# INTRODUCTION

# DESIGN CHANGES

### The design changes for the BART Extension

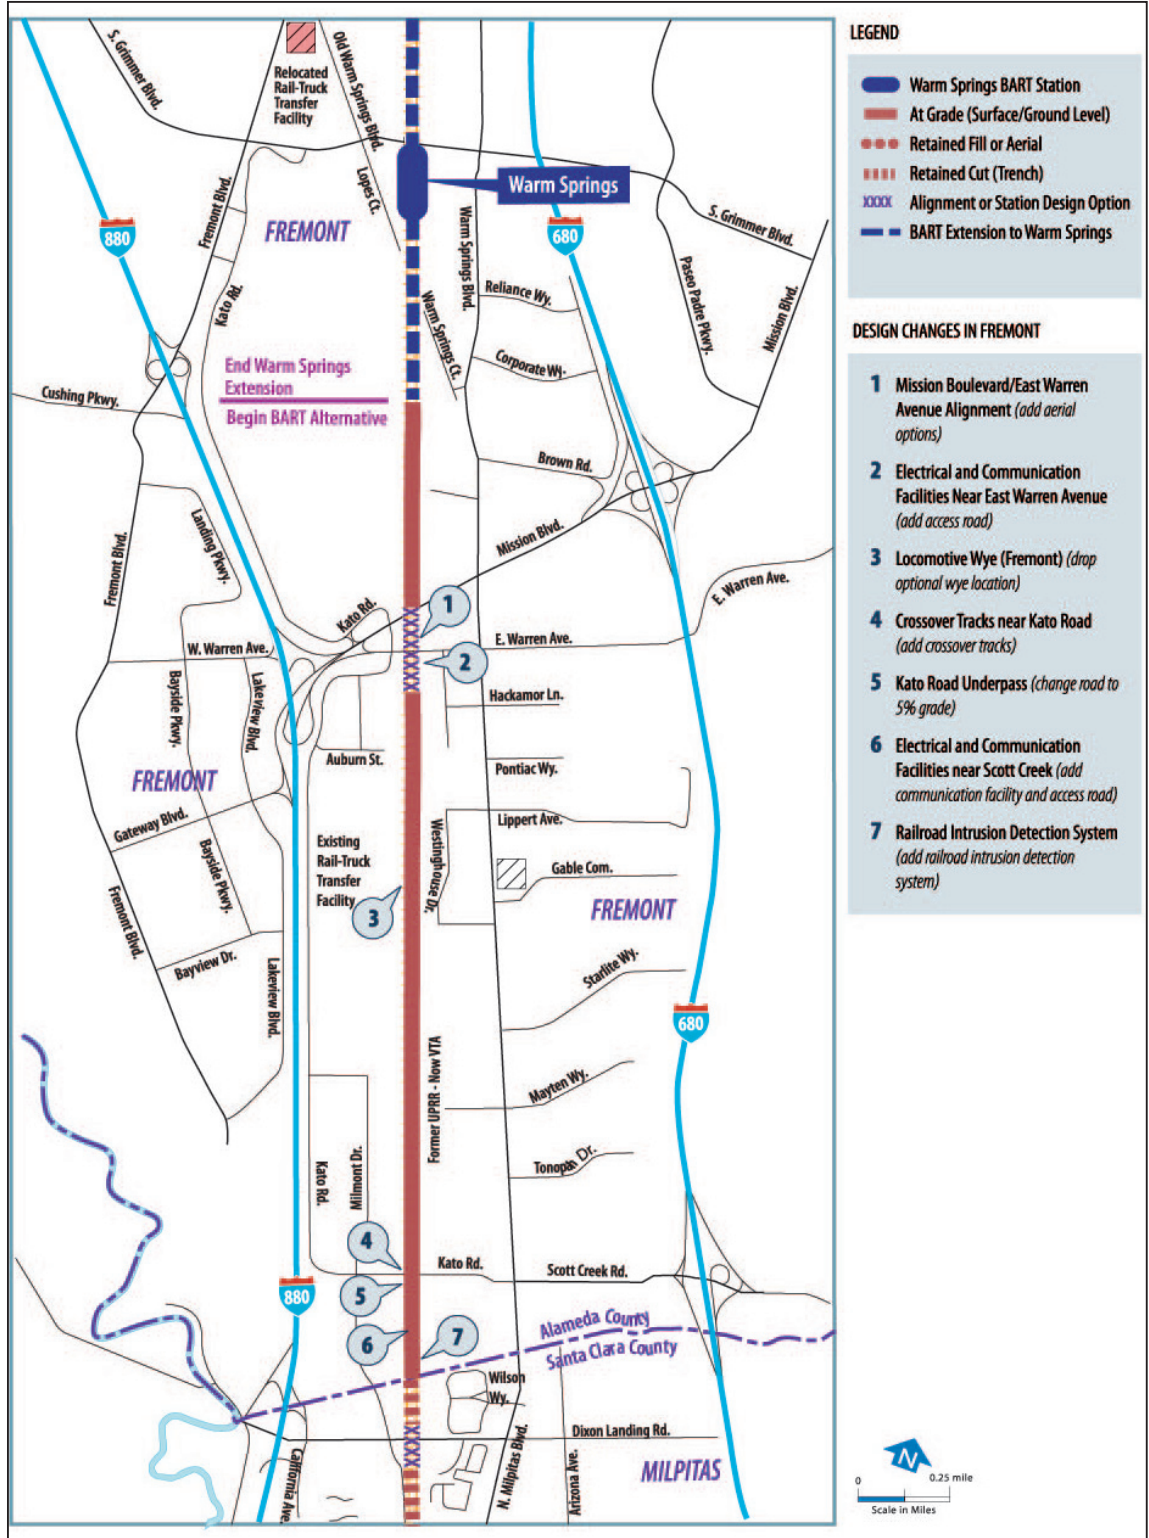
The BART Extension Project in Fremont is shown in Figure 3.2-1, which also shows the locations of the design changes. Plans showing the BART alignment are included in Appendices B and C.

**Design Change 1. Mission Boulevard/East Warren Avenue Alignment.** *In the FEIR, the BART alignment would travel at grade over the Mission Boulevard underpass. South of Mission Boulevard, the BART alignment would be at grade, and other agencies would reconstruct East Warren Avenue as a roadway underpass.*

From Mission Boulevard to south of East Warren Avenue, there are three options for the BART alignment: At Grade, Aerial, and Aerial East. The At Grade Option is discussed and analyzed in the FEIR. However, for easy reference, this option is also included in this SEIR. The At Grade Option assumes that other agencies would reconstruct the existing at grade East Warren Avenue as a new roadway underpass, therefore enabling BART to pass over the roadway on a new bridge structure. However, if East Warren Avenue were not reconstructed as a roadway underpass, BART would pass over the existing roadway on an aerial structure. Two aerial options are considered due to potential impacts to an existing truck-rail transfer facility and other properties.

**Design Change 2. Electrical and Communication Facilities near East Warren Avenue.** *In the FEIR, a traction power substation and train control building are located south of East Warren Avenue and east of the railroad ROW; however, access to the site is not discussed.*

Traction Power Substation SWA and Train Control Building S24 would be located south of East Warren Avenue on the east side of the railroad ROW (STA 78+50). These facilities and location are discussed and analyzed in the FEIR. In this SEIR, an access easement/road to Mission Falls Court is added to the site. The site would remain in the same location regardless of which alignment option is chosen from Mission Boulevard to south of East Warren Avenue (see Design Change 1, Mission Boulevard/East Warren Avenue Alignment).

**Design Change 4. Crossover Tracks near Kato Road.** *In the FEIR, there are no crossover tracks north or south of Kato Road.*

Crossover tracks would be located along the alignment at minimum distance intervals. Several crossover tracks are identified in the FEIR, including crossover tracks near Railroad Court that would be constructed on a floating track slab, a type of track construction used to provide vibration reduction. During the Preliminary Engineering design phase, these tracks were relocated to avoid constructing on the floating track slab (see Design Change 10, Crossover Tracks between Berryessa Creek and Railroad Court). To maintain minimum distance intervals, other crossover tracks along the alignment were also relocated, or added. Therefore, this SEIR includes crossover tracks that would be constructed both north and south of Kato Road (STA 157+00 and STA 170+00). This crossover would provide for 10-car train storage and allow single-track operations around an occasional stored train.

**Design Change 5. Kato Road Underpass.** *In the FEIR, the BART alignment would cross at grade on a new bridge structure over Kato Road, which would be reconstructed as a roadway underpass. The slope of Kato Road would be an 8 percent grade.*

The BART alignment would cross at grade on a new bridge structure over Kato Road, which would be reconstructed as a roadway underpass by VTA (STA 167+00). In the FEIR, the slope of the Kato Road underpass is an 8 percent grade. Due to the slope of the underpass, access to existing driveways serving businesses immediately north of Kato Road and east and west of the alignment would be either relocated or eliminated (with other access points remaining). During Preliminary Engineering, the slope was changed to a 5 percent grade, making the profile of Kato Road slightly longer. This revised slope would accommodate safe stopping distances for a design speed limit of 40 miles per hour, and would impact the same driveways as described in the FEIR.

Figure 3.2-2: Design Changes in Milpitas

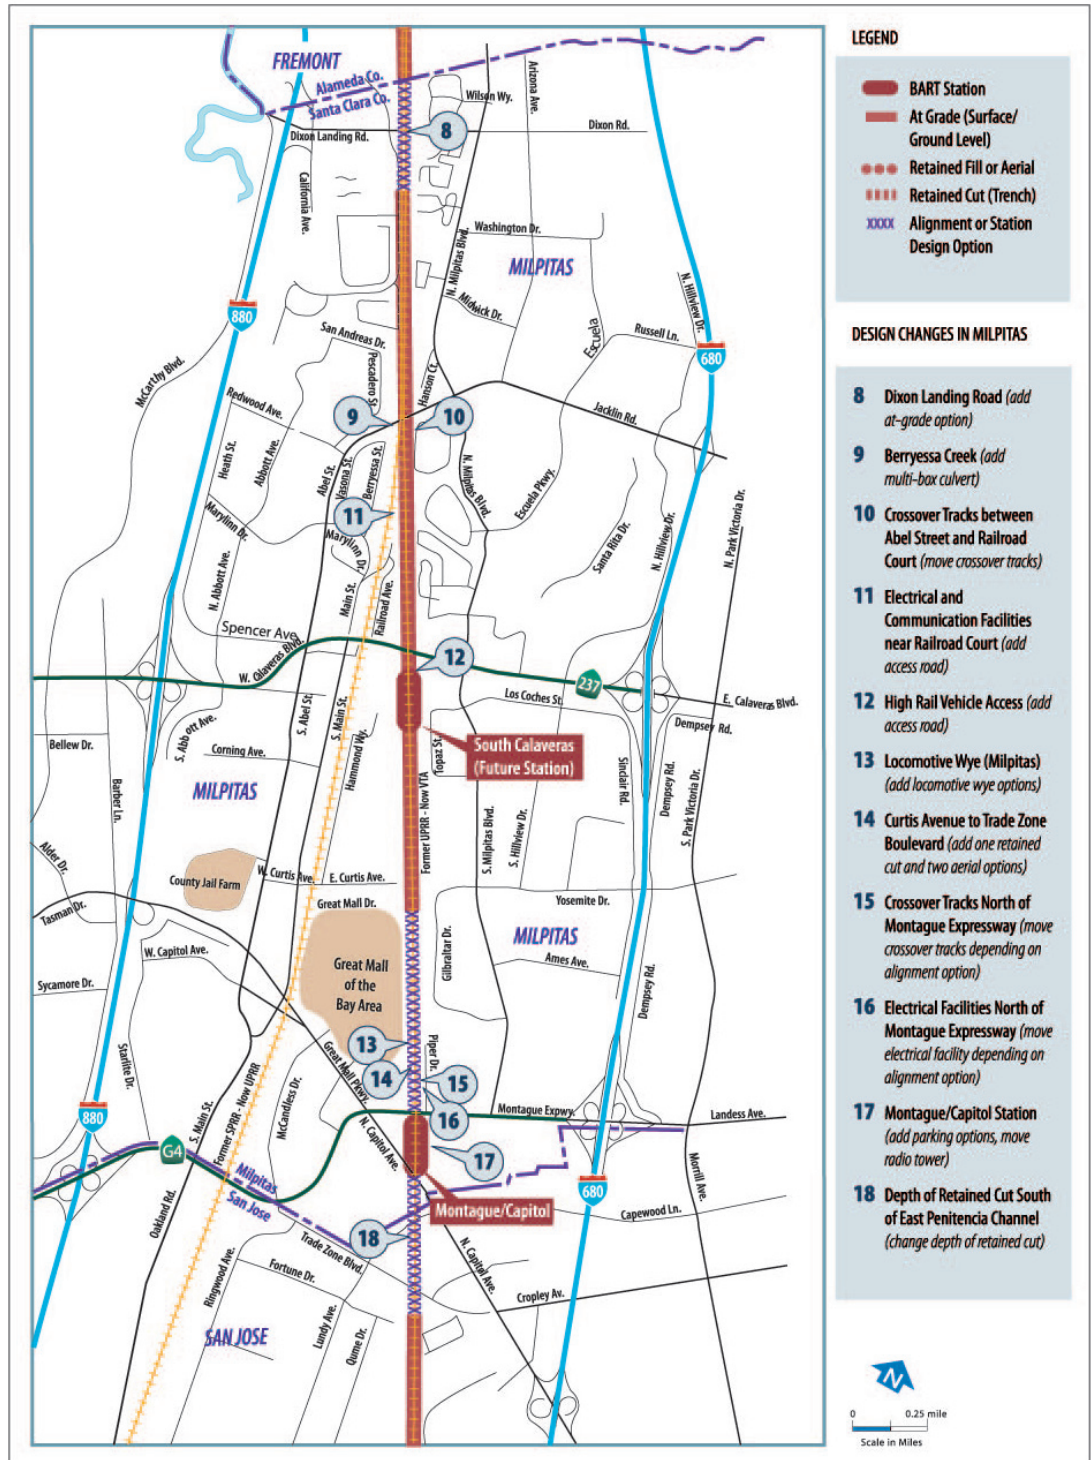
The BART Extension Project in Milpitas is shown in Figure 3.2-2, which also shows the locations of the design changes. Plans showing the

**Design Change 9. Berryessa Creek.** *In the FEIR, BART would pass over Berryessa Creek on a new 100-foot-long bridge.*

BART would cross over Berryessa Creek on a new multi-box culvert. The box culvert would accommodate the planned Berryessa Creek Levees Project by the Santa Clara Valley Water District. This Project would provide flood protection from a 100-year flood event.

**Design Change 10. Crossover Tracks between Berryessa Creek and Railroad Court.** *In the FEIR, crossover tracks would be located near Railroad Court.*

As mentioned in Design Change 4, Crossover Tracks near Kato Road, the crossover tracks near Railroad Court were relocated to avoid construction of the tracks on a floating track slab. Therefore, the crossover tracks identified in the FEIR near Railroad Court are eliminated. Instead, the crossover tracks would be located farther north near the Berryessa Creek crossing (STA 258+00).

**Design Change 13. Locomotive Wye (Milpitas).** *In the FEIR, one option for the locomotive wye would be located north of Montague Expressway and east of the railroad ROW. The other option would be located in Fremont.*

In the FEIR, two options are considered for a locomotive wye: Locomotive Wye Fremont Option and Locomotive Wye Milpitas Option. The Locomotive Wye Fremont Option is discussed in Design Change 3, Locomotive Wye [Fremont]. The Locomotive Wye Milpitas Option is discussed and analyzed in the FEIR. However, for easy reference, this option is also included in this SEIR, but is now called the Relocated Milpitas Wye Option. The SEIR also includes a second option: No Wye Option. Deciding which wye option to implement depends on: 1) discussions with UPRR regarding whether or not a locomotive wye is needed; and 2) negotiations with major industries east of the railroad ROW that use a freight train spur track for shipping service. Depending on the option

**Design Change 14. Curtis Avenue to Trade Zone Boulevard.** *In the FEIR, the BART alignment would be in a long retained cut starting from South of Curtis Avenue, continuing past the Great Mall and underneath Montague Expressway, Capitol Avenue, and Trade Zone Boulevard, and ending south of Trade Zone Boulevard. Montague Expressway, Capitol Avenue, and Trade Zone Boulevard would be supported above BART on new roadway structures. The retained cut configuration would allow a UPRR freight track to cross the BART alignment on a bridge to gain access to a new locomotive wye and an existing spur track that serves industries east of the BART alignment.*

South of Curtis Avenue (STA 330+00) to south of Trade Zone Boulevard, there are four alignment options for the BART alignment: Retained Cut Long, Retained Cut Short, Aerial Long, and Aerial Short. The Retained Cut Long Option is discussed and analyzed in the FEIR. However, for easy reference, this option is also included in this SEIR. If the Relocated Wye Option were implemented (see Design Change

Figure 3.2-3: Design Changes in San Jose

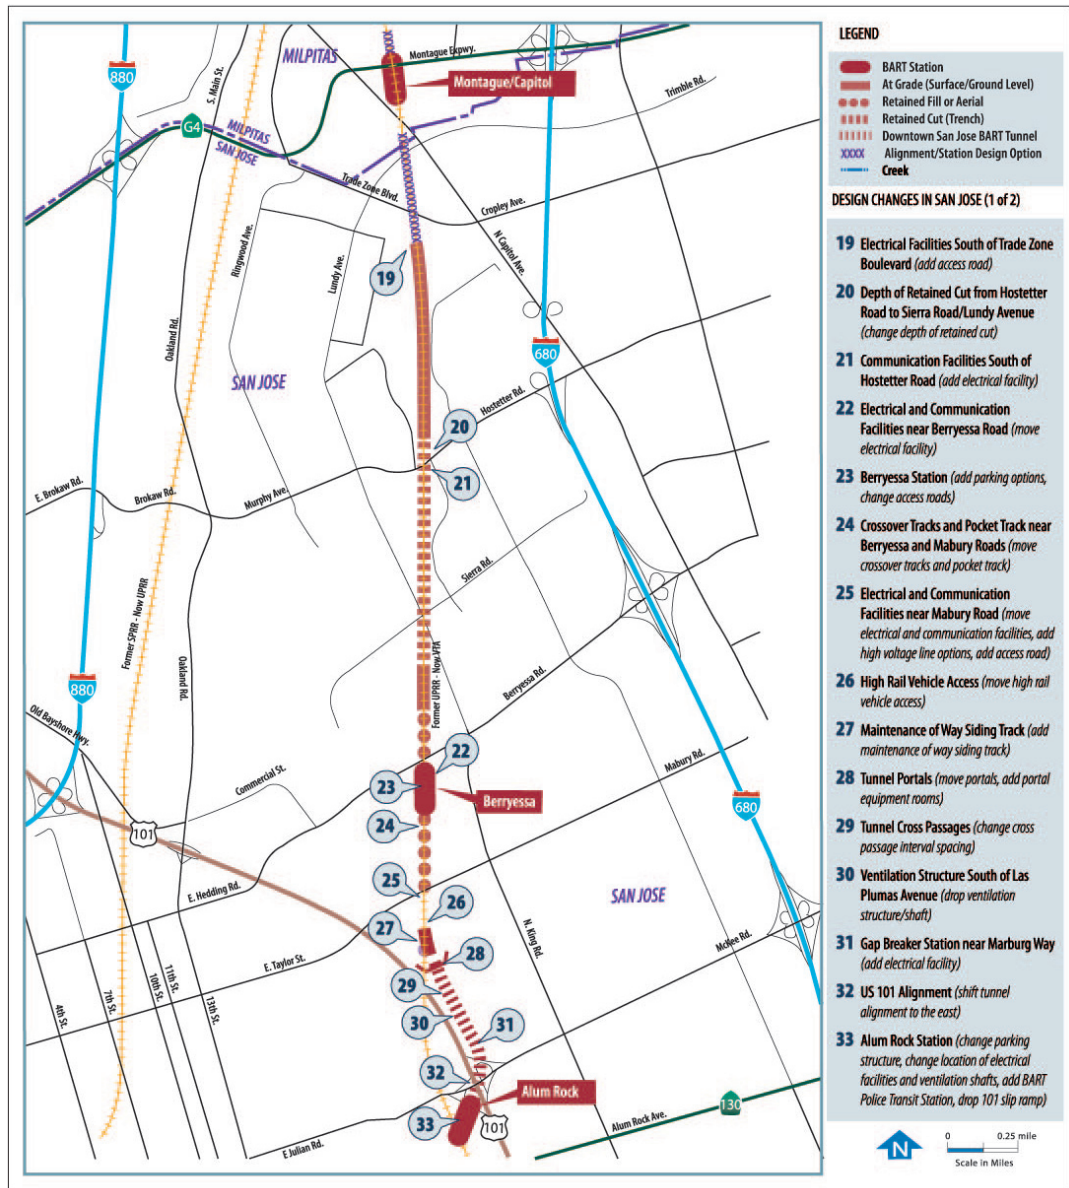
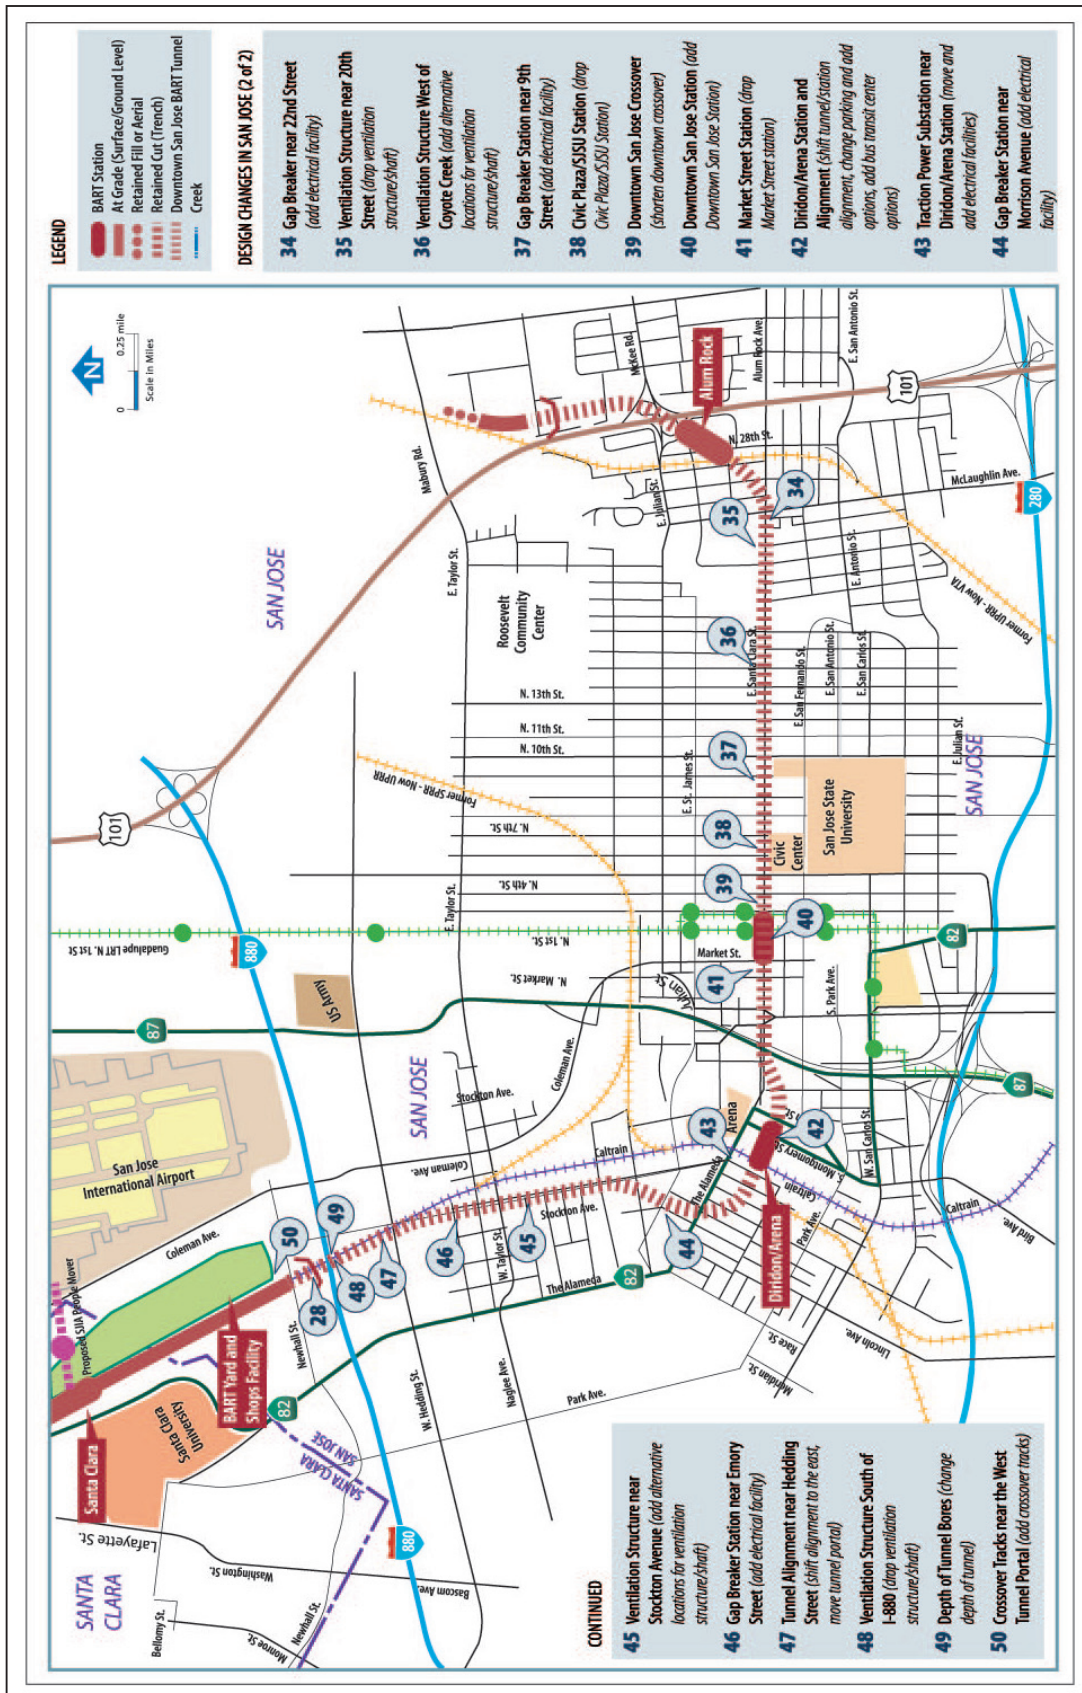
The BART Extension Project in San Jose is shown in Figures 3.2-3 and 3.2-4, which also show the locations of the design changes. Plans showing the BART alignment are included in Appendices B and C. There are four stations in the City: Berryessa Station, Alum Rock Station, Downtown San Jose Station, and Diridon/Arena Station. The plans for these stations are shown in Appendix D.

**Design Change 19. Electrical Facilities South of Trade Zone Boulevard.** *In the FEIR, a traction power substation is located south of Trade Zone Boulevard and west of the railroad ROW.*

Traction Power Substation SMB would be located south of Trade Zone Boulevard partially within commercial parking areas on the west side of the railroad ROW (STA 416+00). This facility and location are discussed and analyzed in the FEIR. Two options for an access easement/road are under consideration. Either access easement/road would connect the site to Qume Drive.

**Design Change 20. Depth of Retained Cut from Hostetter Road to Sierra Road/Lundy Avenue.** *In the FEIR, the depth of the retained cut from north of Hostetter Road to south of Sierra Road/Lundy Avenue varies from approximately 20 to 50 feet below grade. The deepest portions are under the Hostetter Road and Sierra Road/Lundy Avenue overcrossings.*

**Design Change 21. Communication Facilities South of Hostetter Road.** *In the FEIR, a train control building is not identified south of Hostetter Road.*

**Design Change 22. Electrical and Communication Facilities near Berryessa Road.** *In the FEIR, a traction power substation would be located west of the railroad ROW, and either south of Aschauer Court or north of Berryessa Road.*

Figure 3.2-5: Design Changes in Santa Clara

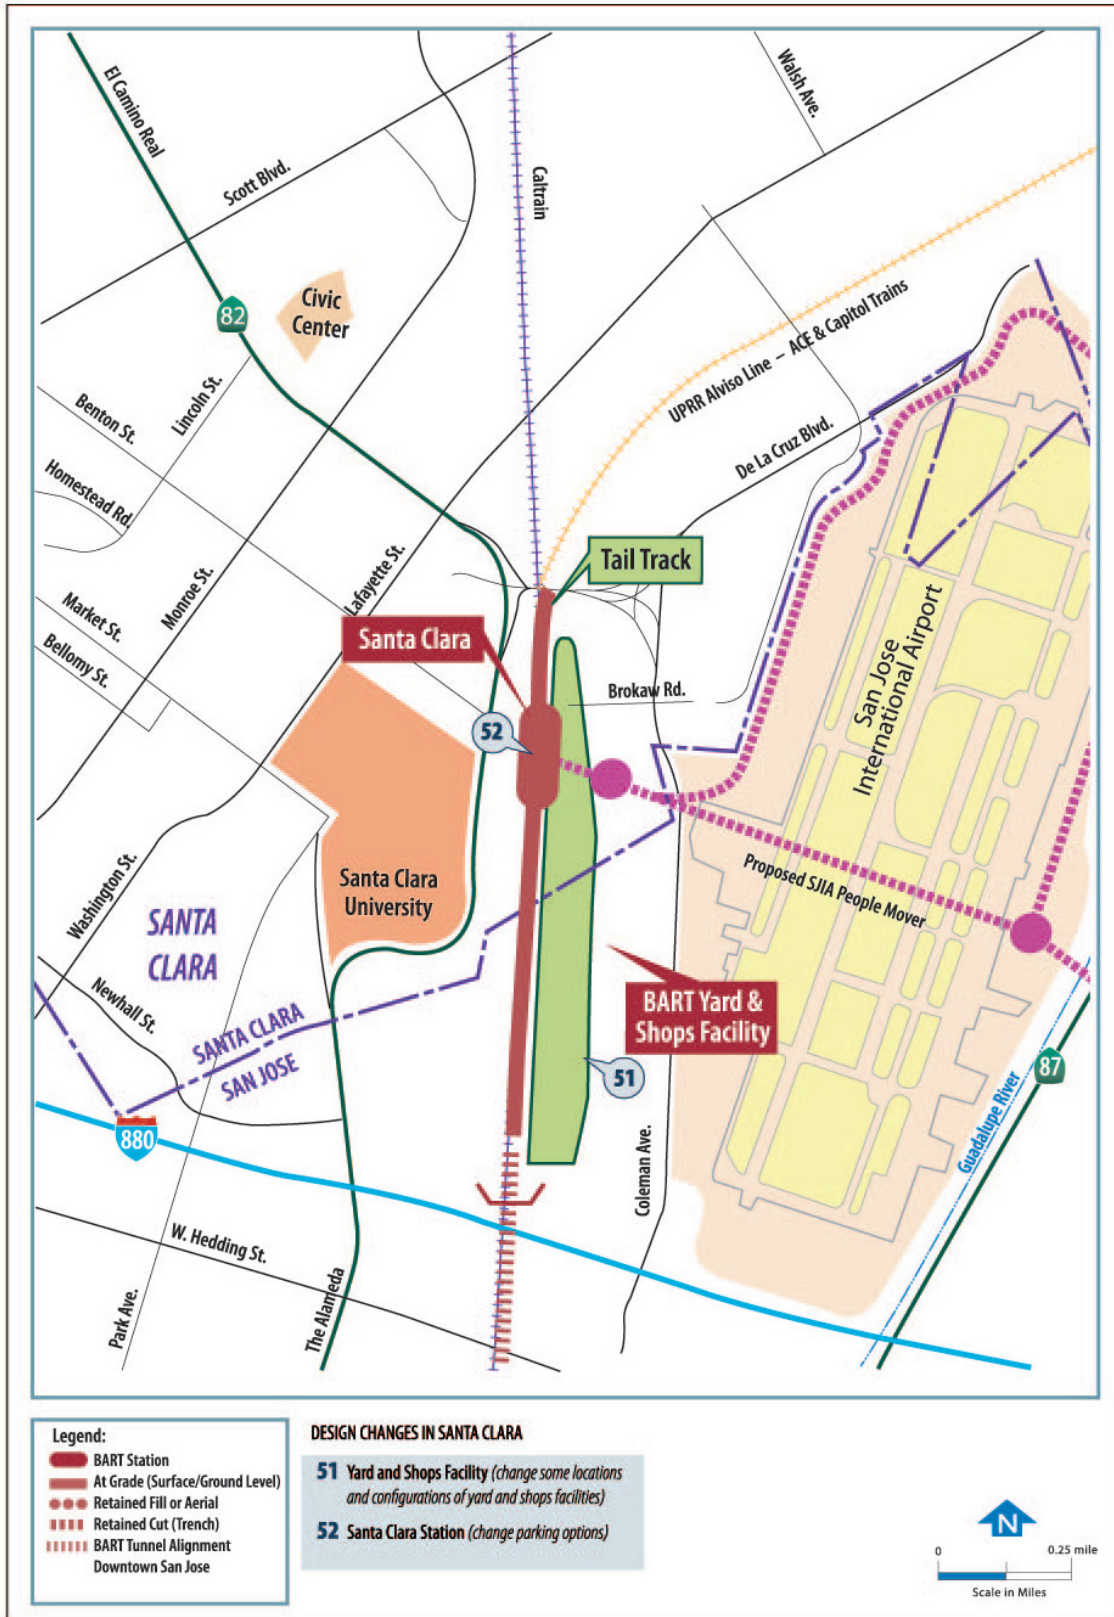
The BART Extension Project in Santa Clara is shown in Figure 3.2-5, which also shows the locations of the design changes. Plans showing the BART alignment are included in Appendices B and C. There is one station in the city: Santa Clara Station. The plans for this station are shown in Appendix D. The yard and shops facility, which is partially located in San Jose but mostly located in Santa Clara, is discussed entirely in this section.

**Design Change 51. Yard and Shops Facility.** *San Jose. In the FEIR, the yard and shops facility in San Jose would include property from south of I-880 and east of the Caltrain railroad ROW to the San Jose/ Santa Clara city line. Buildings south of I-880 would include a train control building; a two-story, 30,000-square foot Station/Structure Maintenance and Training Facility; and a 20,000-square foot Systems, Wayside Equipment, and Non-Revenue Vehicle Maintenance Facility and Shops. A ventilation structure and vent shaft would be located at this site. A radio tower would be located midway between Brokaw Road and Newhall Street. The site would include a BART Transit Police Station.*

The design of the yard and shops facility (formerly called the BART Maintenance Facility in the FEIR) underwent several changes from the Conceptual Engineering design phase to the Preliminary Engineering design phase. Most notably, several buildings in San Jose were relocated from south of I-880 to north of I-880. This eliminated the need for property acquisition south of I-880. The tail track area was reconfigured to terminate just north of De La Cruz Boulevard, which eliminated the need for property acquisition north to Lafayette Boulevard. The BART Transit Police Station was relocated to the Alum Rock Station to provide a more centralized location along the alignment. Several other design changes also occurred; therefore, all features of the facility are discussed in this SEIR.
